CAV TOOL – ADDITION JSP17-17

Public hearing at the request of CAV Tool for Special Land Use Permit, Preliminary Site Plan, and Stormwater Management Plan Approval. The subject property is located in section 26, north of Nine Mile Road and west of Heslip Drive and is zoned I-1 (Light Industrial). The applicant is proposing to construct a 1,800 square foot addition to an existing industrial building with associated site improvements. A special land use is required for uses adjacent to residential zoned property.

PLAN REVIEW CENTER REPORT

JSP17-17

4 BARRIER-FREE PARKING SIGN
AS101 1" = 1'-0"

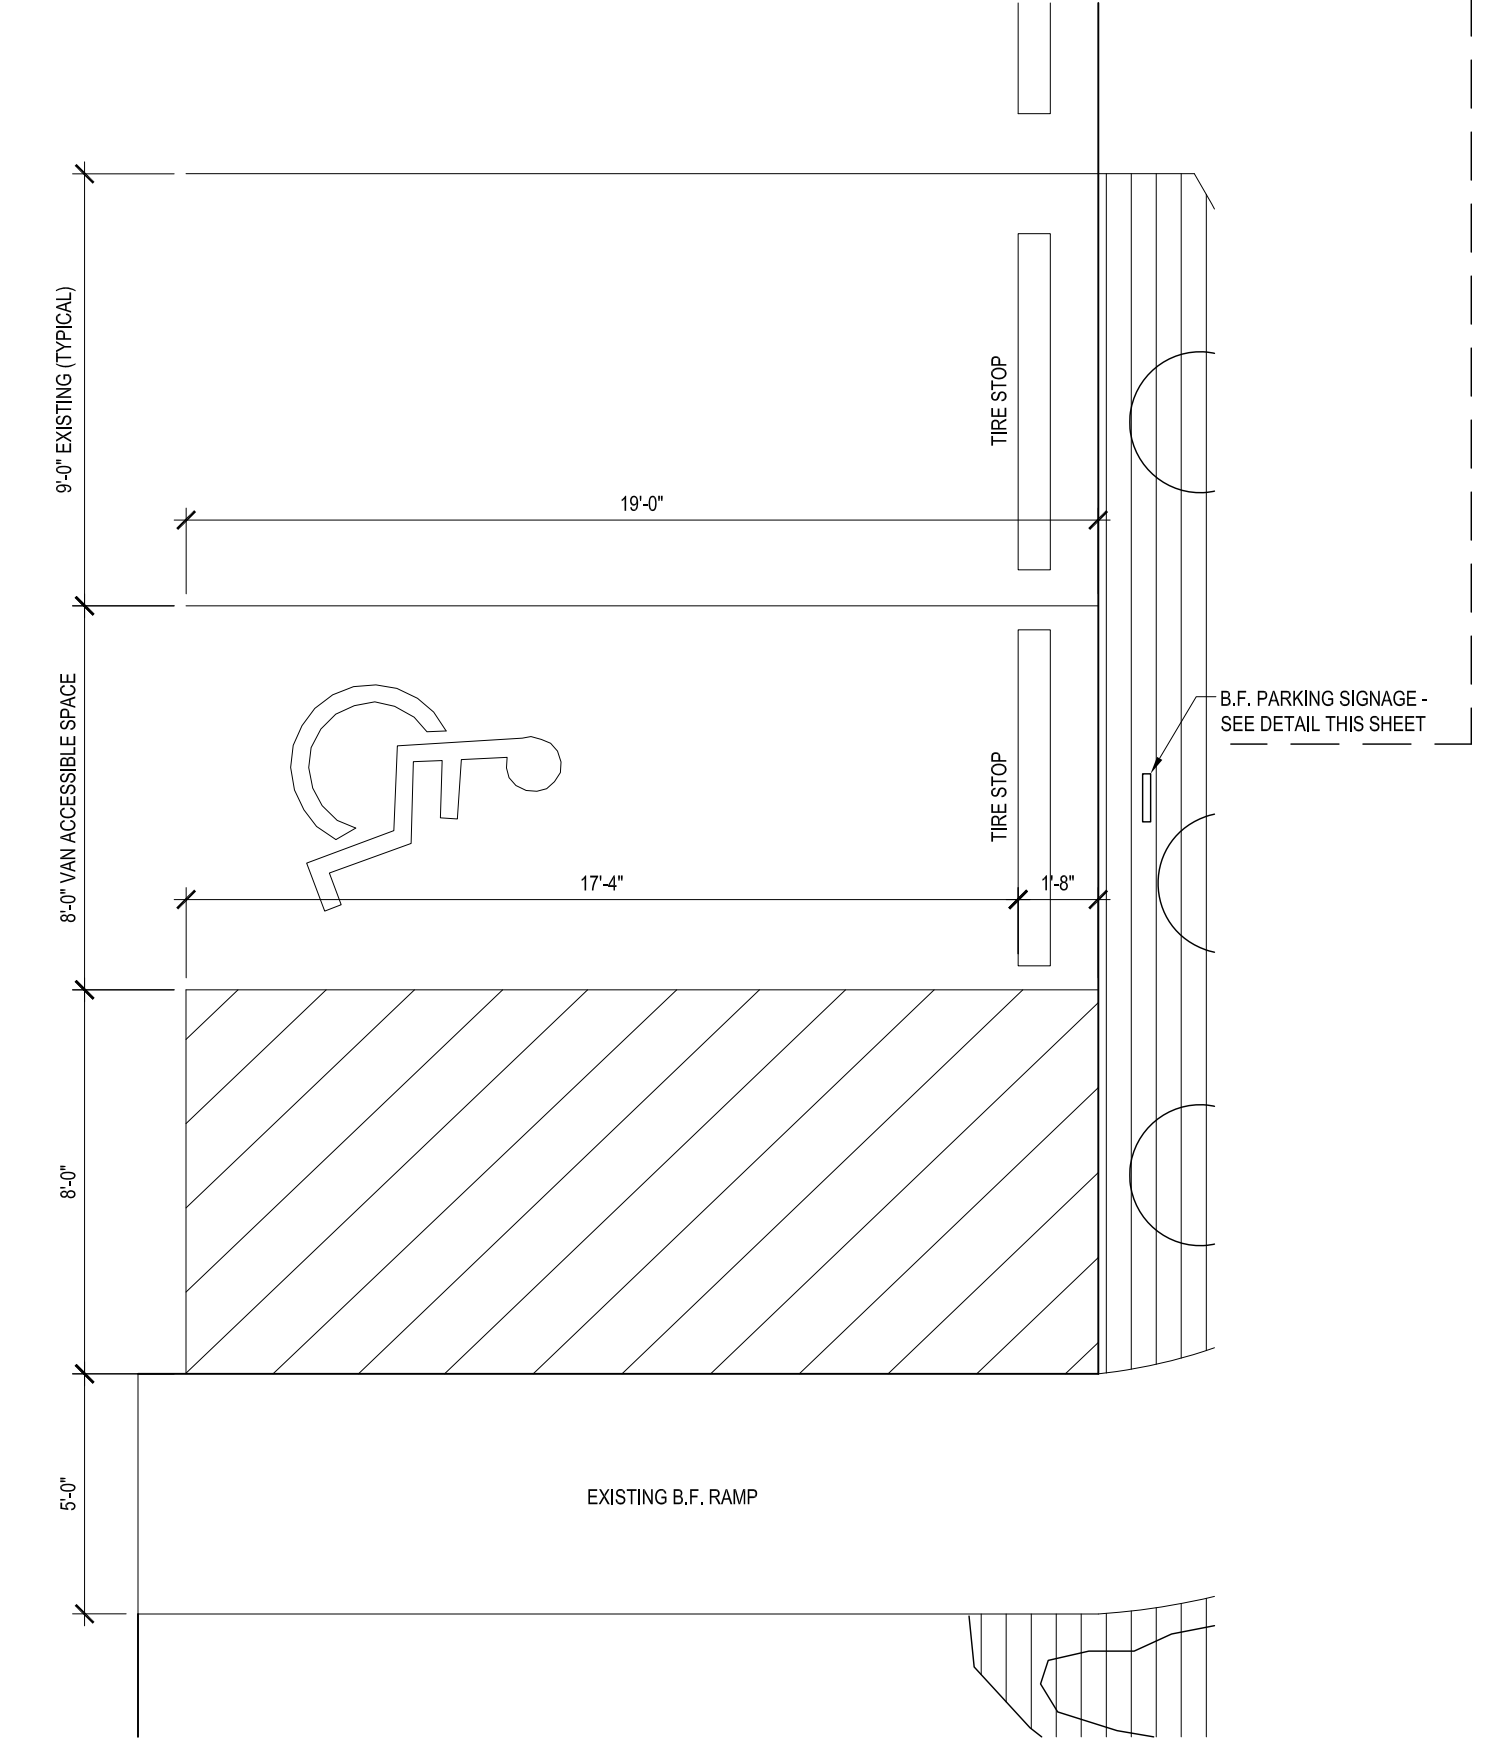
1. Specify MMUTCD compliant traffic control sign R7-8 and R7-8P for the accessible parking space.

Specify MMUTCD compliant traffic control sign R7-8 and R7-8P for accessible parking space.

The requested signage will be provided.

EVERGREEN TREE PLANTING DETAIL
NO SCALE

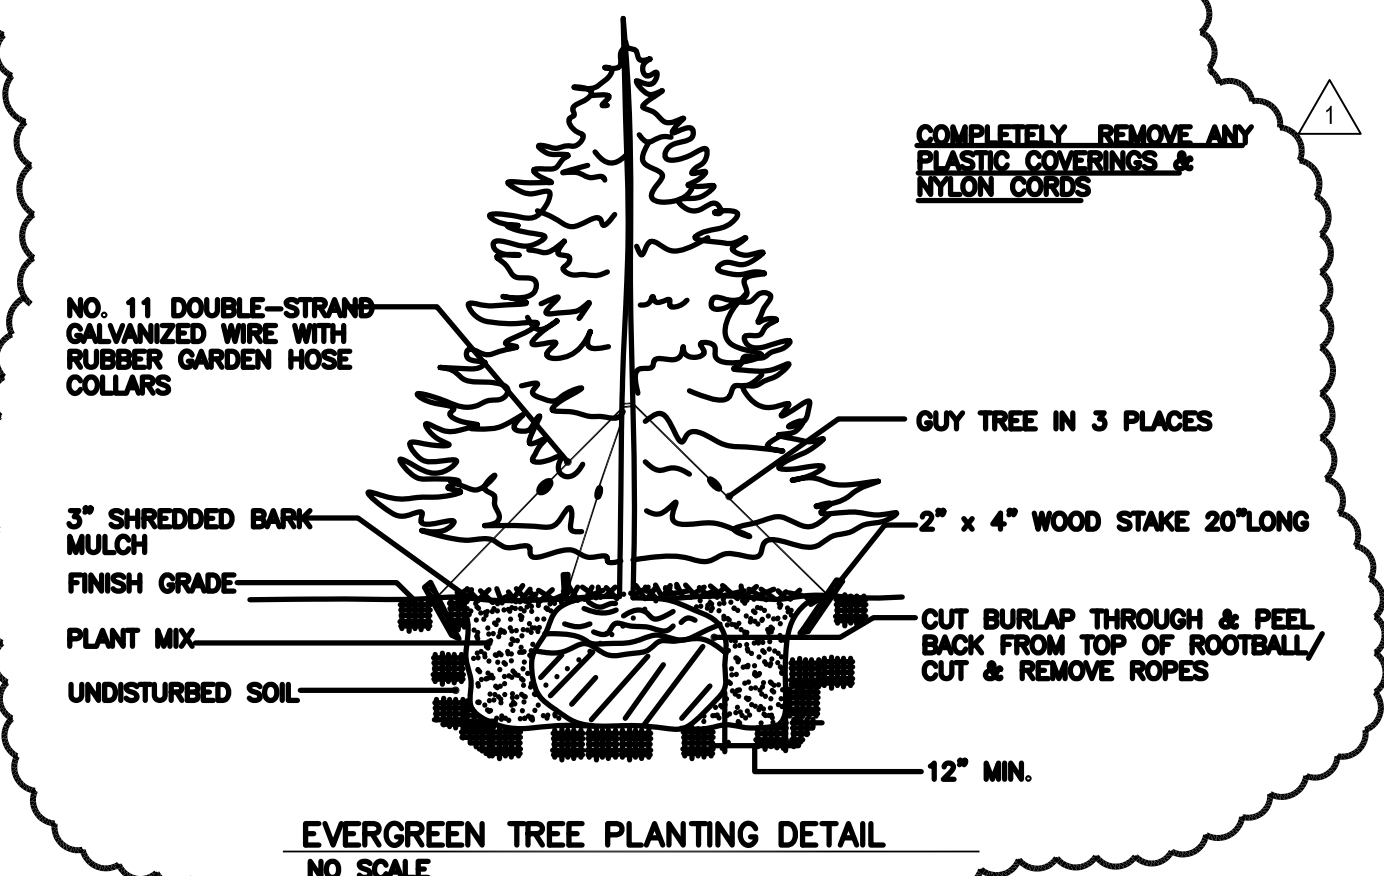
1. To screen the addition, a line of evergreens to screen the loading zone was requested. 5 Emerald Green Arborvitae are proposed, spaced approximately 17 feet on center.
2. The proposed landscaping is not sufficient to screen the new rear loading area from the adjacent apartments. Emerald arborvitae shrubs only attain a width of about 3-4 feet. **It is suggested that a different variety, perhaps Mission Arborvitae (Thuja occidentalis**

'Techny'), which can get to 7-8' wide be used, and at least 11-13 of them be spread out along the southern 9 spaces in a staggered pattern. The Emerald Arborvitae could still be used if desired, but at least 23-25 would be required, spread out in a staggered pattern along the southern 9 spaces to achieve the required screening. Other evergreen species such as medium height junipers that get at least 6-8 feet tall may also be used if desired. In any case, the loading zone needs to be fully screened along the southern 9 parking spaces.

The proposed landscaping is not sufficient to screen the new rear loading area from the adjacent apartments. Emerald arborvitae shrubs only attain a width of about 3-4 feet. It is suggested that a different variety, perhaps Mission Arborvitae (*Thuja occidentalis* 'Techny'), which can get to 7-8' wide be used, and at least 11-13 of them be spread out along the southern 9 spaces in a staggered pattern. The Emerald Arborvitae could still be used if desired, but a least 23-25 would be required, spread out in a staggered pattern along the south 9 spaces to achieve the required screening. Other evergreen species such as medium height junipers that get at least 6-8 feet tall may also be used if desired. In any case, the loading zone needs to be fully screened along the southern 9 parking spaces.

The Mission Arborvitae will be used as suggested.
